**Variation to the Territory Plan 368 –
City and Gateway South Northbourne Avenue Corridor**

Variation to the Territory Plan 368

City and Gateway South
Northbourne Avenue Corridor
(Barry Drive/Cooyong Street to
Antill/Mouat Street)

Figure 5: Additional requirements – north of Macarthur Avenue

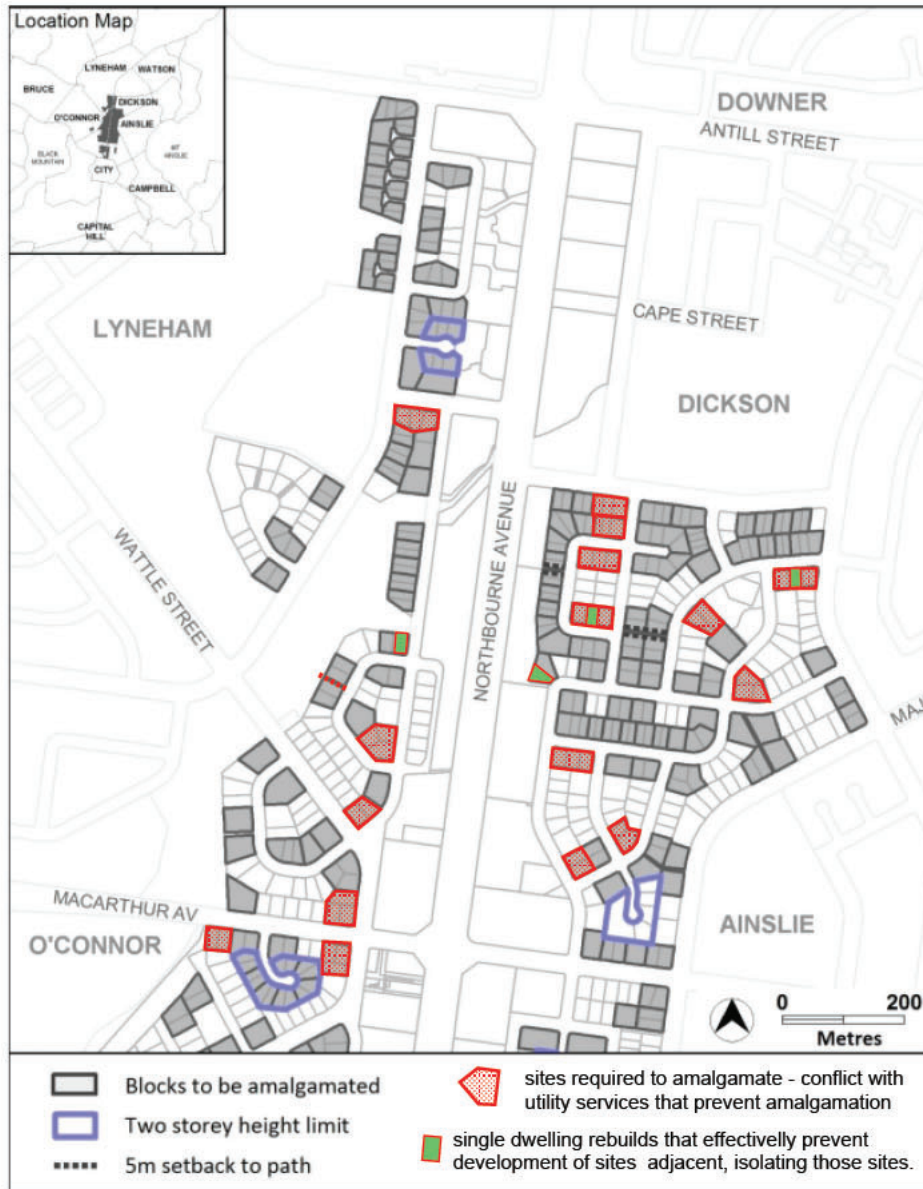
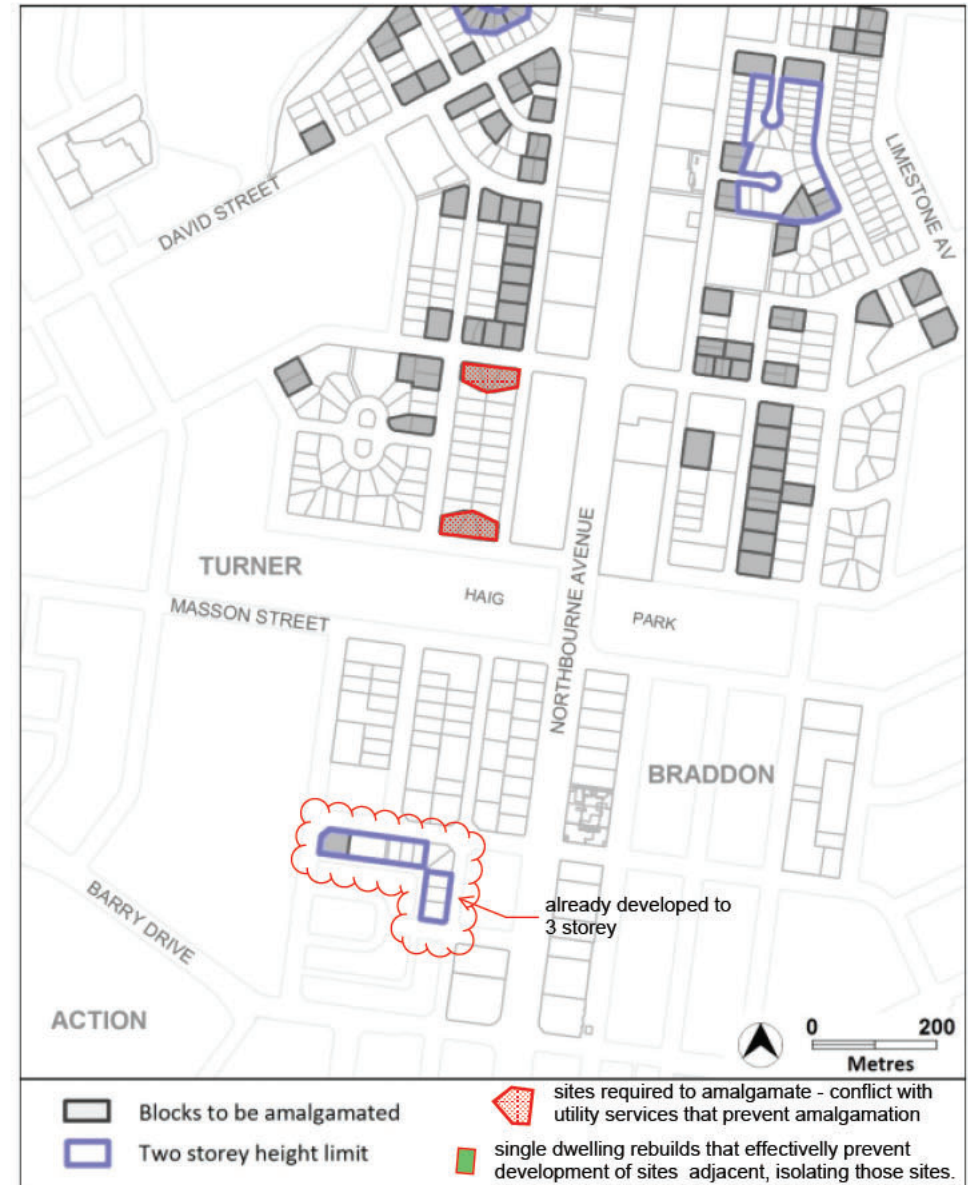
- **Rule 43 (consolidation)** relating to the minimum block consolidation requirement for Blocks 1-3 Section 46 Turner (Condamine Street) refer figure 6 page 27. This rule is unworkable on these specific blocks given the large sewer easement and stormwater easement between blocks 2 and 3 section 46. The sewer is of a size, depth and required fall that prevents its relocation thereby preventing development across the blocks. I have highlighted this on the map below.

Rules	Criteria	Proposed Amendments with comment and reasoning
<p>8.1 Consolidation</p>		
<p>R43</p> <p>Where multi-unit housing development is proposed, required minimum block consolidations are <u>required when shown in Figures 5 and 6</u>.</p> <p>In all other cases, minimum block consolidations are required between two or more blocks where:</p> <ul style="list-style-type: none"> a) existing single dwellings have shared walls b) sites are less than 16m wide at the front building line c) single block development cannot provide minimum private open space dimensions for all dwellings d) TCCS does not support vehicle access for a single block development e) development would otherwise result in an isolated block. <p>For the purposes of this rule, an <i>isolated block</i> is a standard block with multi-unit development existing or proposed to each side boundary or</p>	<p>C43</p> <p>The minimum Bblock consolidation is not required where the lessee(s) of the block(s) to be developed demonstrate to the satisfaction of the Authority that:</p> <ul style="list-style-type: none"> a) <u>Block consolidation is not possible due to location of inground or overground utility networks, or;</u> a) b) suitable redevelopment of the remaining block(s) can be achieved, through the submission of a concept design, <u>and;</u> b) c) the concept design required at a) includes a sufficient level of detail to enable assessment of the feasibility and demonstrate integration of a possible future development on the adjoining block(s) with the proposed development, <u>and;</u> c) d) redevelopment of the block(s) that are to be developed can be achieved while ensuring the amenity of any existing dwelling(s) on the remaining block(s) is/are protected, <u>and</u> 	<p>Amendment Suggested:</p> <ul style="list-style-type: none"> • Delete reference to Figures 5 and 6. • Criteria added to clarify that block amalgamation is not required where utility assets prevent amalgamation <p>Comment and reasoning:</p> <p><i>Figures 5 and 6 are a collated and simplified version of the existent control plans in the INPC, however, Figures 5 and 6 are significantly flawed, carrying the inherent problems of the existing control plans, where utility assets prevent amalgamation of a significant number of blocks.</i></p> <p><i>Block consolidations can rely upon reworded rule, which is sufficient.</i></p> <p><i>Figures 5 and 6 also make further changes limiting development to RZ4 zoned blocks which are regressive and in obvious conflict with zone objectives</i></p> <p><i>Refer to marked up Figures 5 and 6 attached to this submission</i></p>

<p>Figure 5: Additional requirements — north of Macarthur Avenue</p> <p>Figure 6: Additional requirements — south of Macarthur Avenue</p>		<p>Amendment Suggested:</p> <ul style="list-style-type: none"> • Delete Figure 5 and 6 <p>Comment and reasoning:</p> <p><i>Figures 5 and 6 are a collated and simplified version of the existent control plans in the INPC, however, Figures 5 and 6 are significantly flawed, carrying the inherent problems of the existing control plans, where utility assets prevent amalgamation of a significant number of blocks.</i></p> <p><i>Block consolidations can rely upon reworded R43.</i></p>

Consideration should be provided however to remove the figures 5 & 6 and rely on the wording/ rules and criteria. The plans are high level and do not reflect where some blocks may be further limited by utilities or other site constraints. Figures 5 and 6 also make further changes limiting development to RZ4 zoned blocks which are regressive and conflict with zone objectives.
